**PUR-1270
ADDENDUM NO. 5
INVITATION TO BID**

CONOCOCHEAGUE TREATMENT PLANT ENR UPGRADE

DATE: Thursday, May 26, 2016

METHANOL FACILITY
 SECTIONS
 AND
 DETAILS
 DRAWING NO.: S-14
 SHEET NO.: 112 OF 327
 SCALE: 3/4"=1'-0"

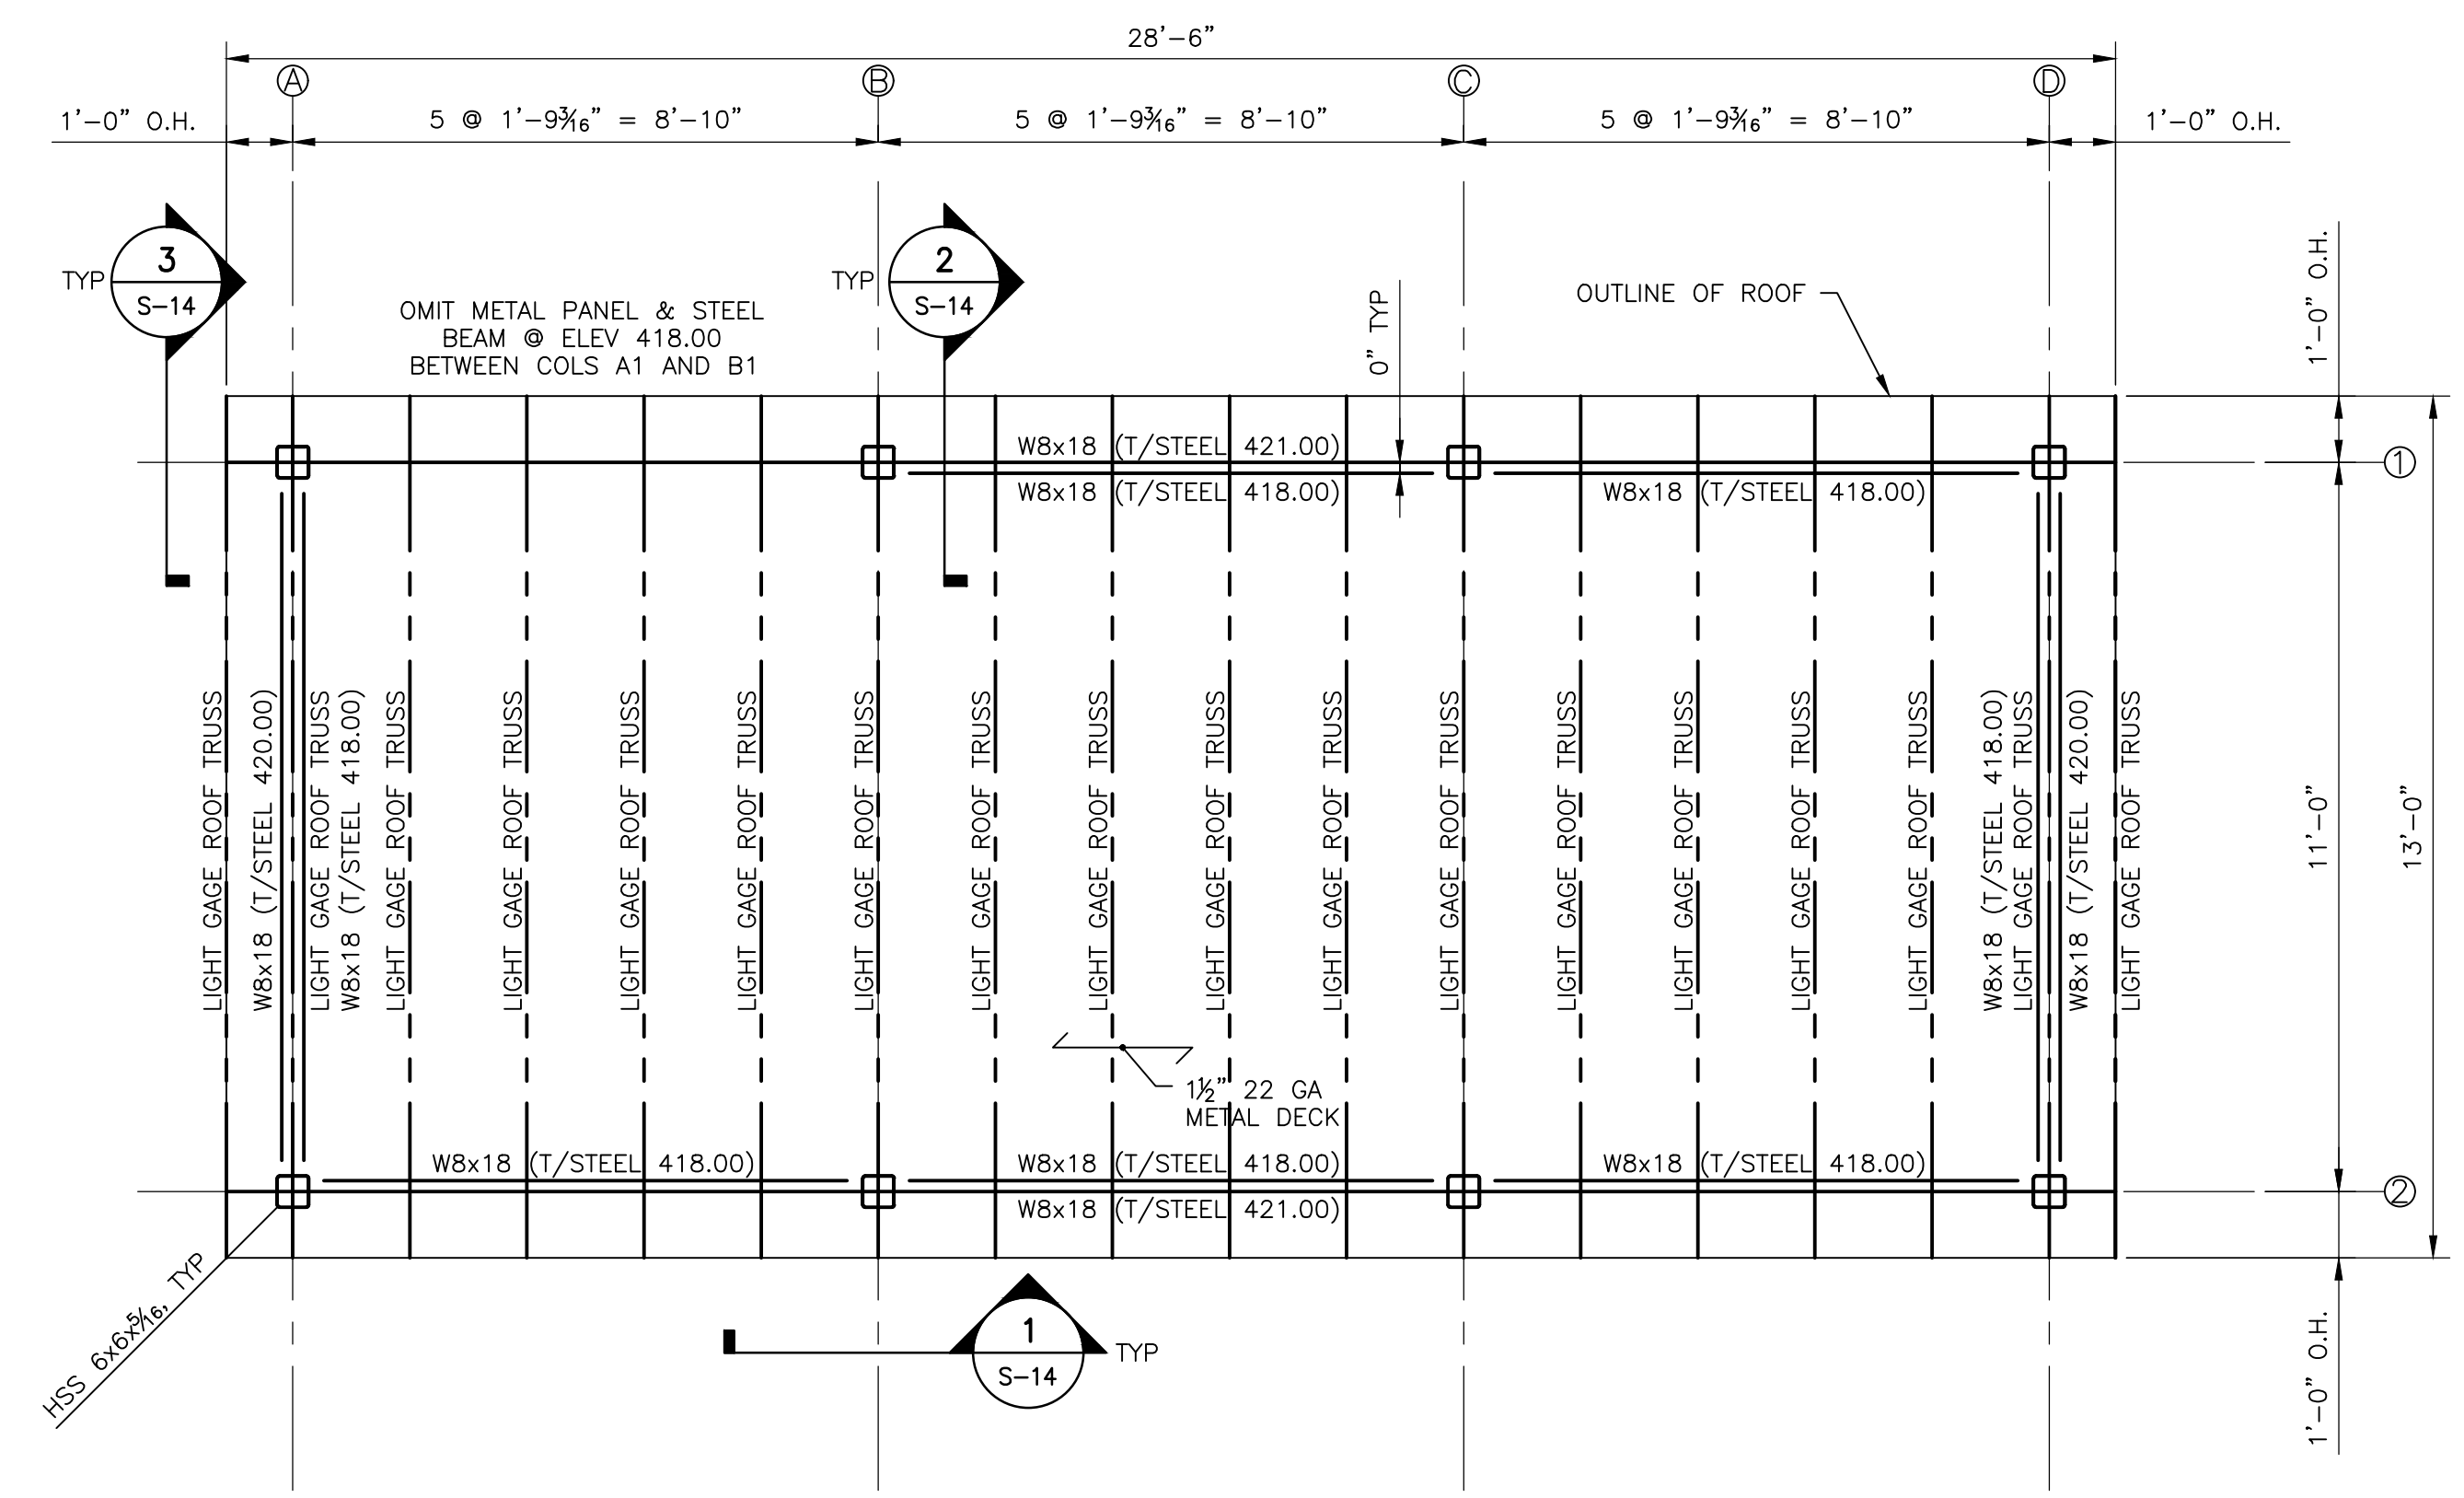
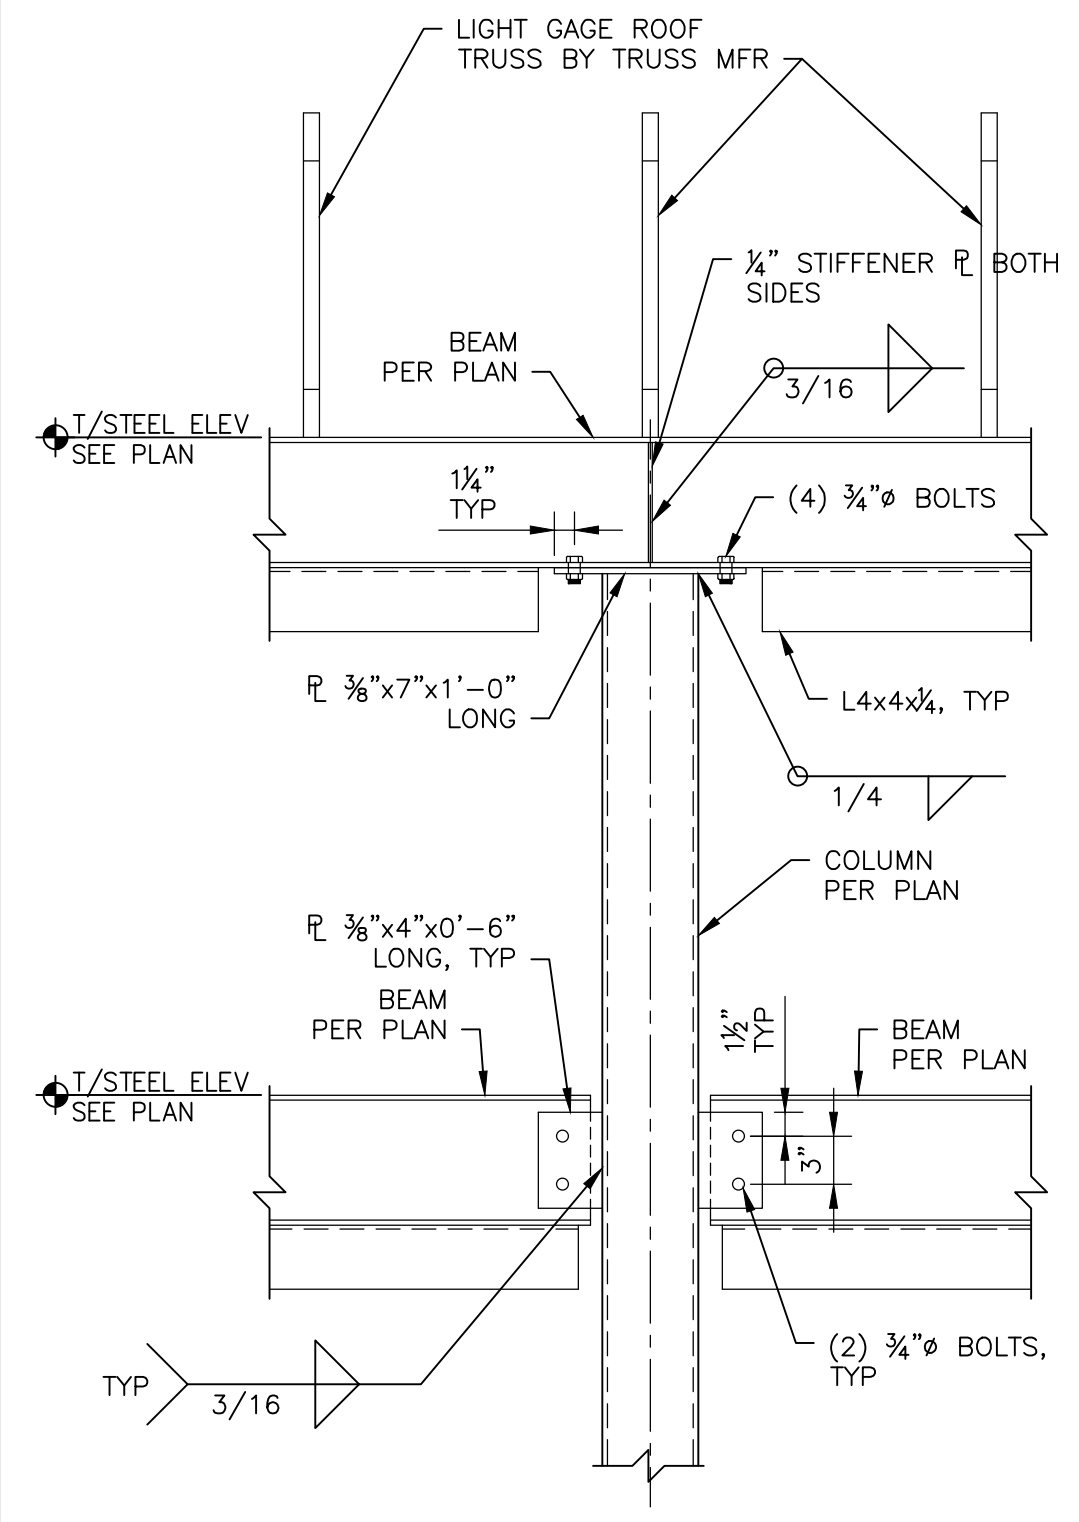
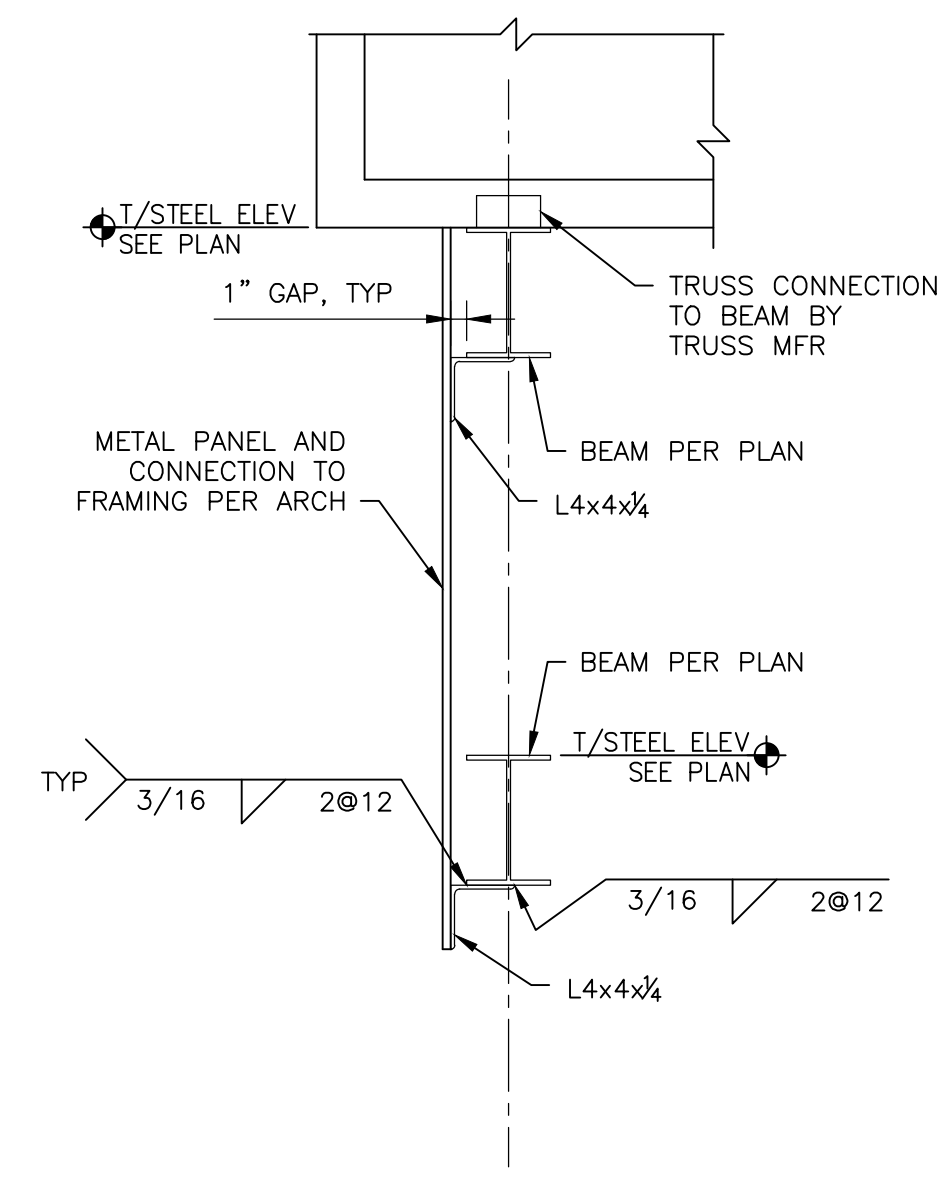
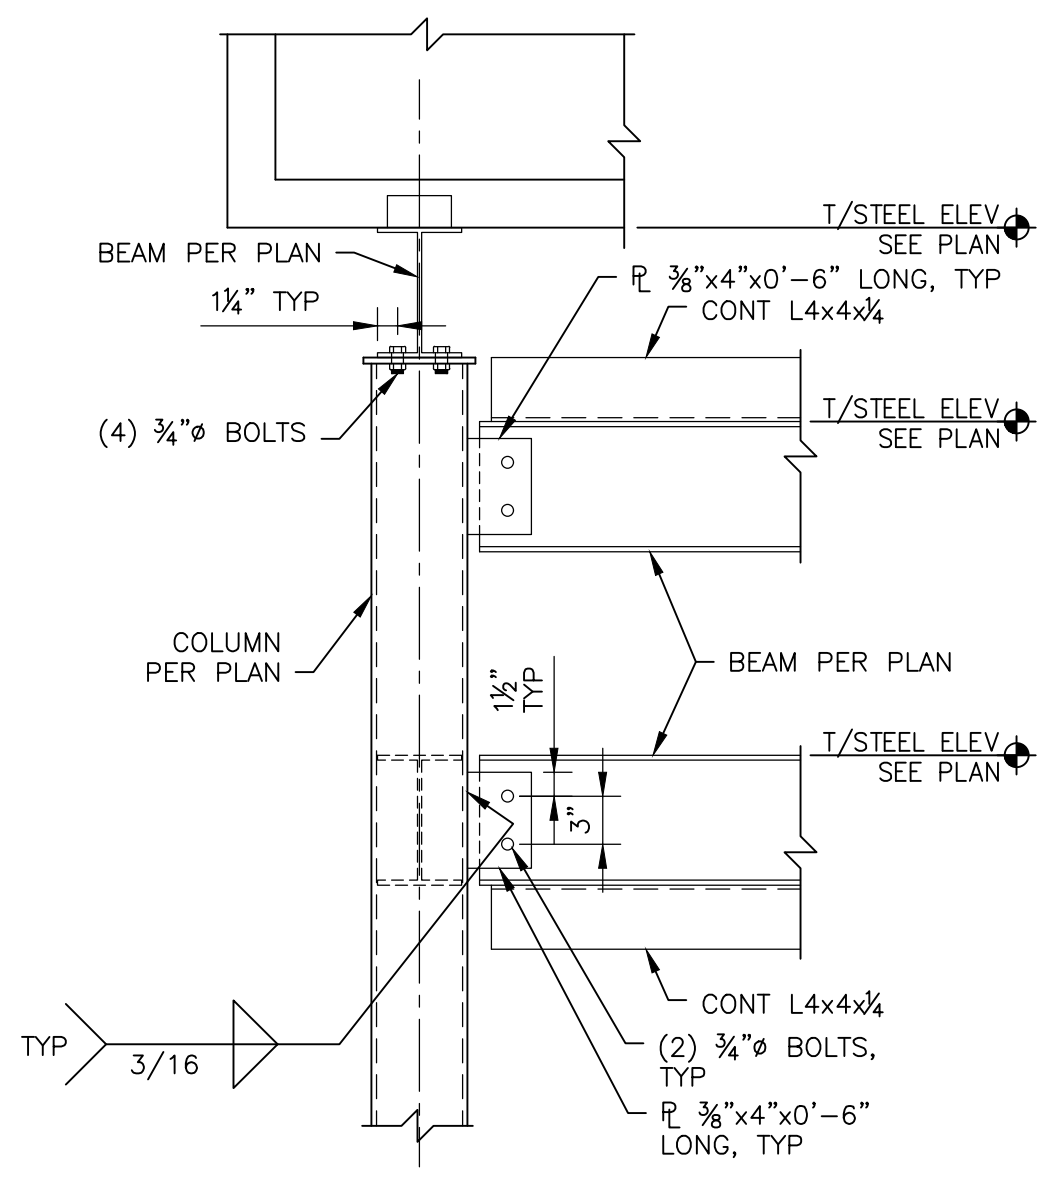
ITEM NO. 5: *Inquiry:* Drawing PM-22 shows a concrete stair outside of the footprint of the Methanol structure with no below grade support. Please provide information for the foundation for this stair.

ITEM NO. 24: *Inquiry:* Drawing S-14 note 3 calls for plastic bird screen mesh on the underside of roof trusses & S-13 shows metal panels only on the structural steel. Detail 3 on A-6 calls for metal soffit on the underside & shows metal panel & plywood on the vertical side of the trusses. What is correct & should the plywood and metal panels be on the vertical as well as across the top of the trusses or only across the structural steel per S-13?

Response: See revised Sheets S-13 and S-14 attached to this Addendum.

Response: The architectural details are correct. See Detail A and E on Sheet A-6.
